## DEVELOPMENT ASSESSMENT REPORT

<b>Application No.</b>	REV/2020/0017
<b>Address</b>	27 Barton Avenue HABERFIELD NSW 2045
<b>Proposal</b>	Section 8.2 review of DA/2020/0323 for the construction of a carport.
<b>Date of Lodgement</b>	13 August 2020
<b>Applicant</b>	Mr James Salmon
<b>Owner</b>	Ms Connie M Zysek
<b>Number of Submissions</b>	2 objections
<b>Value of works</b>	\$12,000.00
<b>Reason for determination at Planning Panel</b>	S8.2 Review where recommendation is to uphold previous refusal.
<b>Main Issues</b>	Heritage conservation
<b>Recommendation</b>	Refusal
<b>Attachment A</b>	Plans of proposed development
<b>Attachment B</b>	Heritage Impact Statement
<b>Attachment C</b>	Draft Conditions (if review is upheld)
<b>Attachment D</b>	DA Report for DA/2020/0323

Attachment A – Plans of proposed development

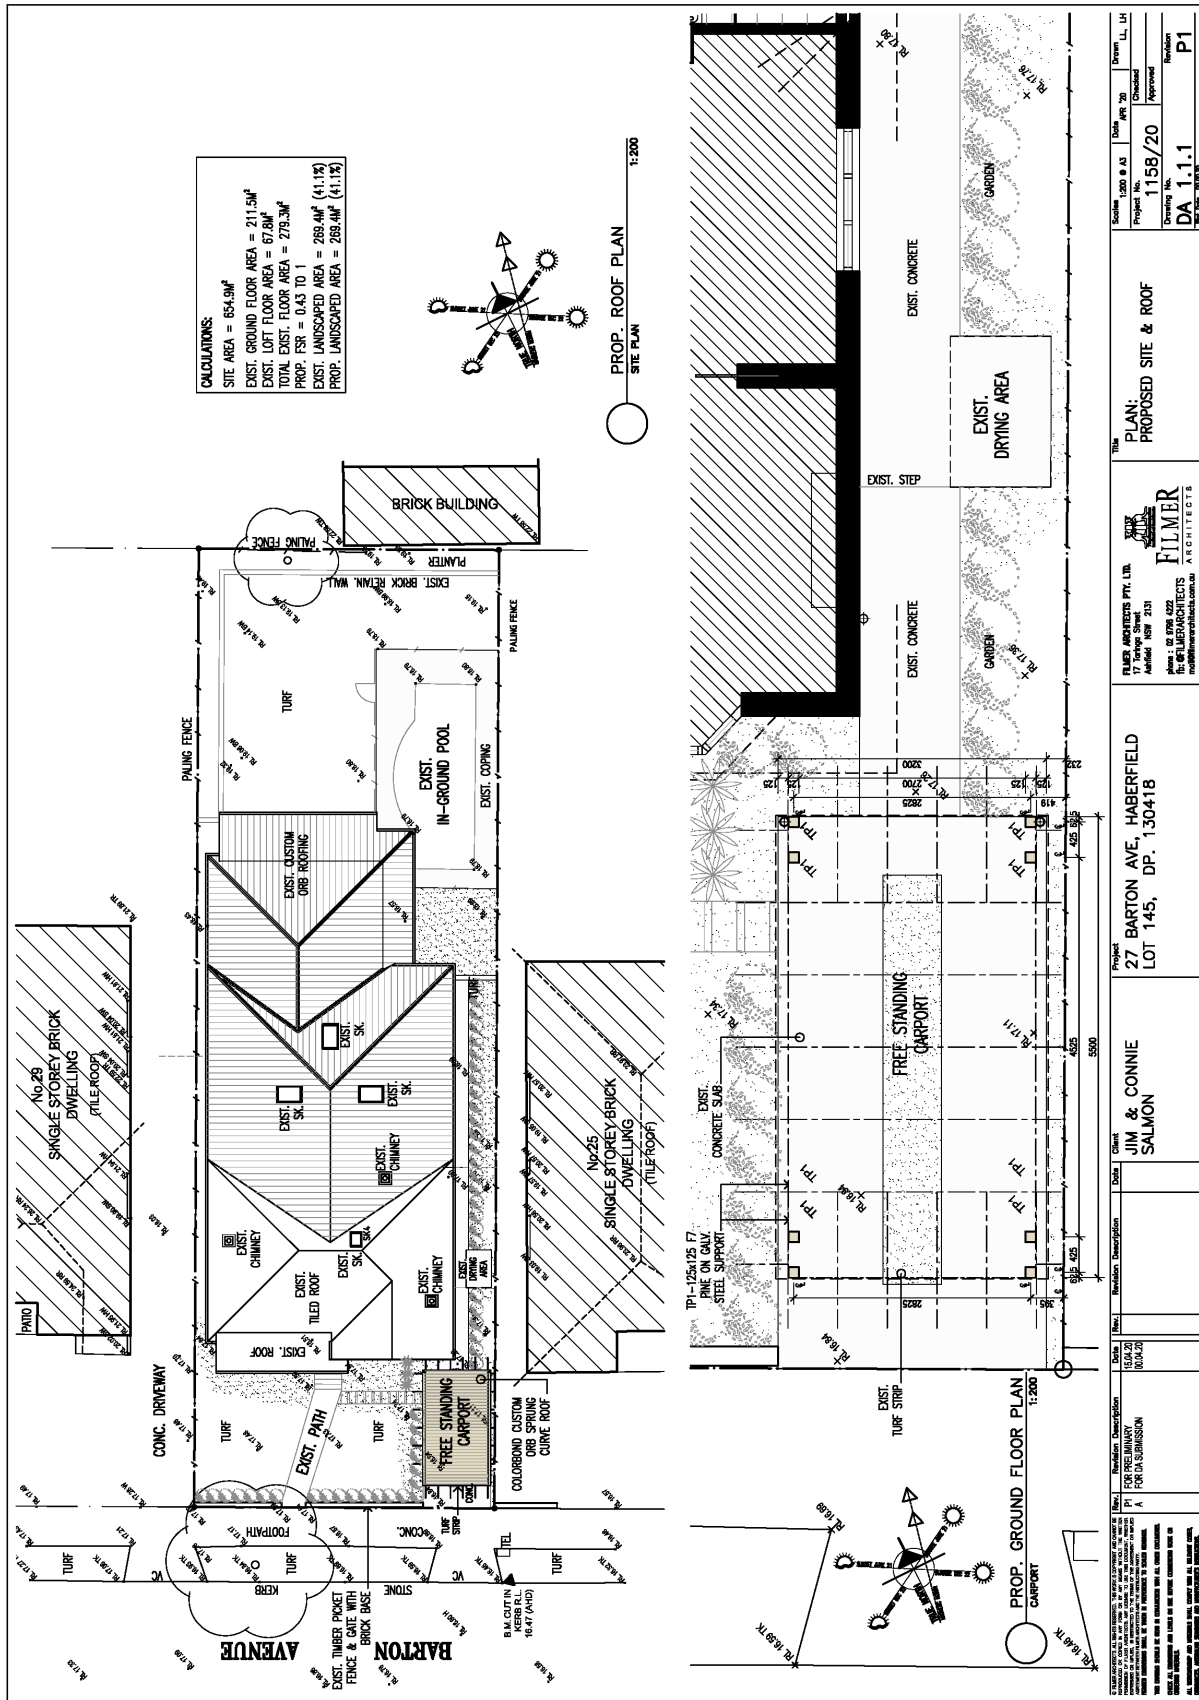
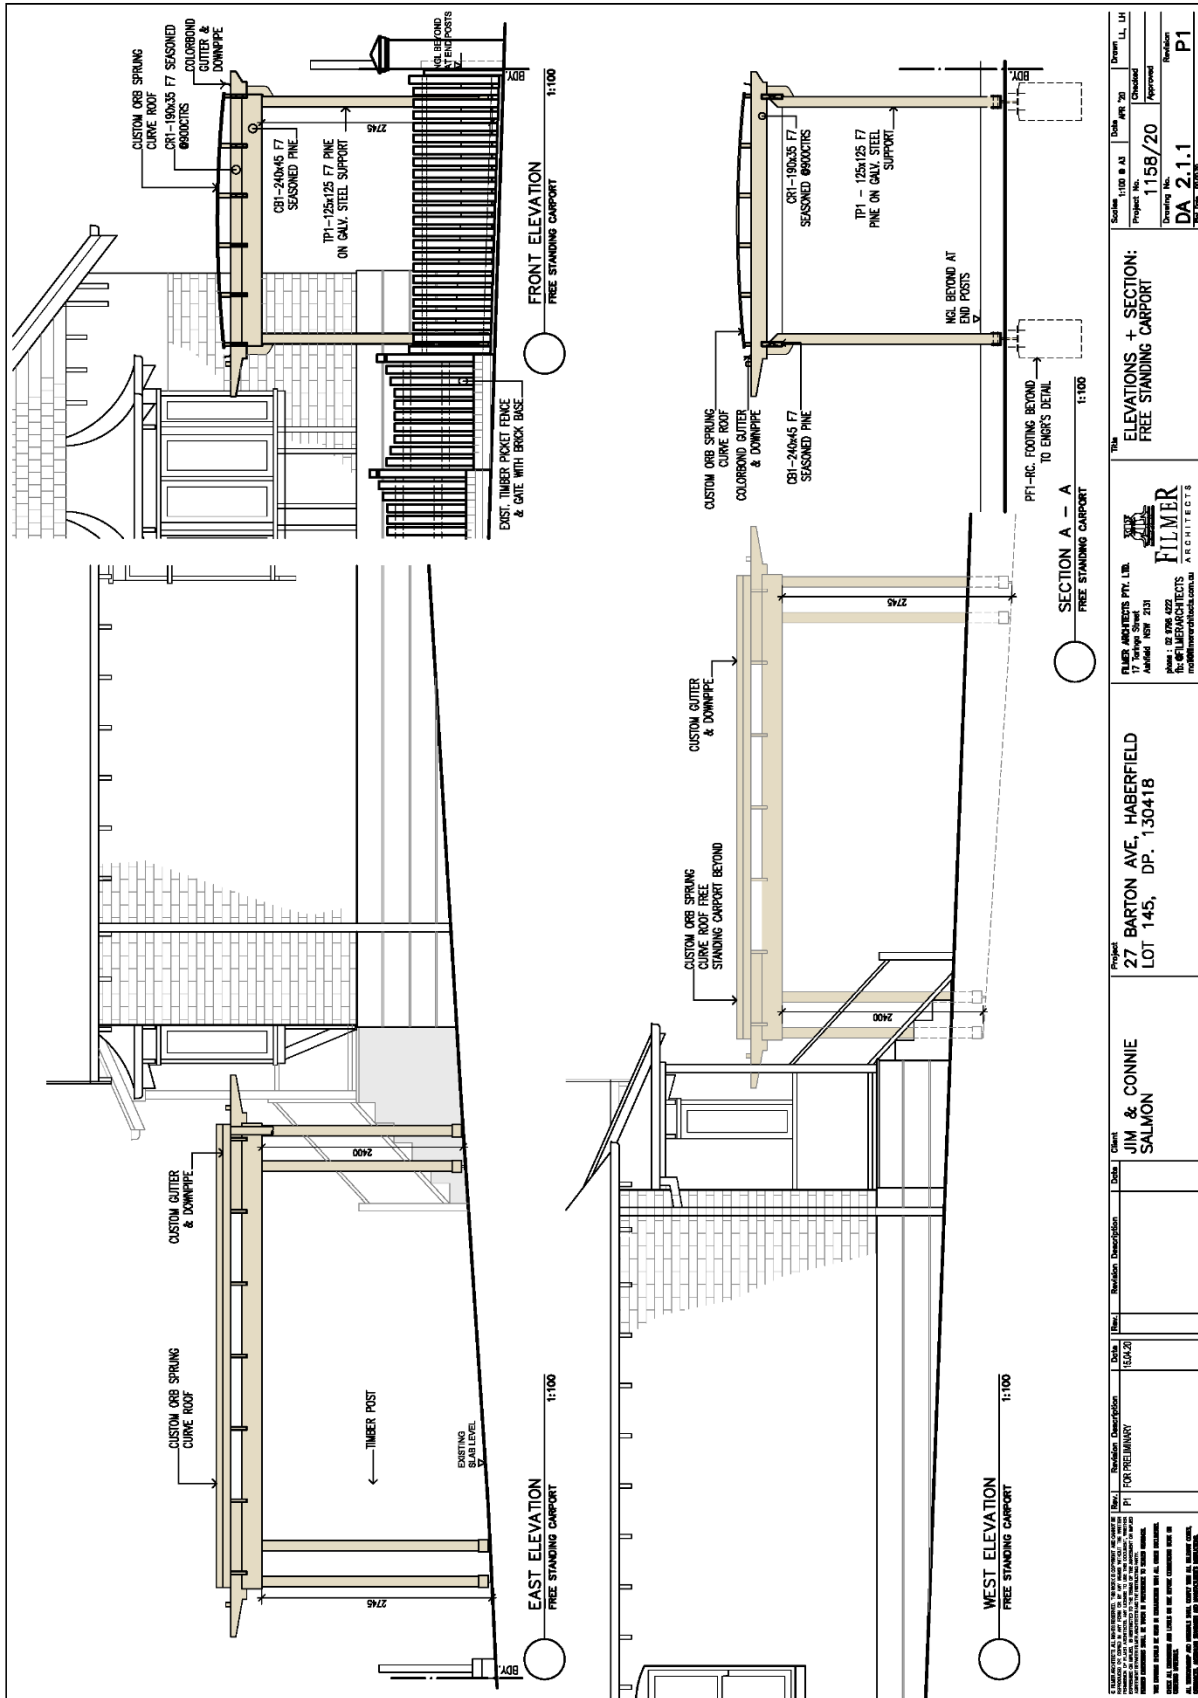
The architectural plans submitted with the application still include a roof over the proposed carport, which is not permitted under the relevant provisions of the IWCDP 2016. However, the information provided with the application outlines that the applicant is willing to remove the roof of the proposed carport.

Notwithstanding the above, it is considered if the roof of the proposed carport were removed, its purpose would become redundant, as it does not provide shelter or protection for a vehicle. In addition, this outcome would also make the remaining elements of the carport, including its timber posts, become redundant as well. However, if the timber posts were to remain, it is considered adverse heritage/ streetscape impacts would still be present, as described above.
